Newcastle International Airport Ltd RNAV SIDs Post Implementation Review (PIR)

CAP 1984

Published by the Civil Aviation Authority, 2020

Graphic from KLM dated 7 Feb 20, showing the last 100 KLM aircraft to fly the GIRLI 3X or GIRLI 1Y SID

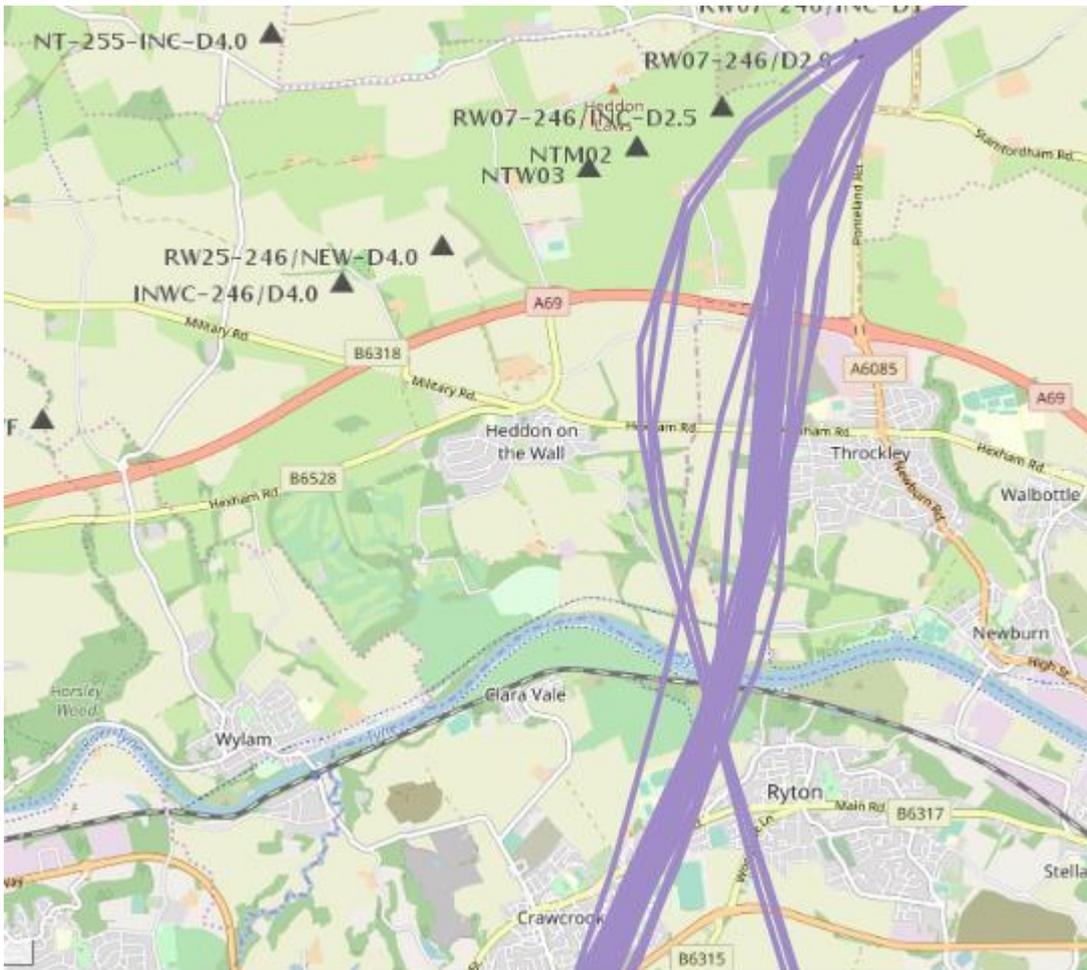
- b) There has only been one piece of direct feed-back from an airline that utilises Newcastle Airport. KLM (Royal Dutch Airlines) provided a track plot over a map (7 Feb 20 via email) that showed ground track for the 'last 100' KLM aircraft to depart Newcastle on the GIRLI 3X and GIRLI 1Y SIDs. The diagram [Annex C] shows the KLM aircraft flew between Throckly and Heddon-on-the-Wall. No other Airline feed-back has been received.
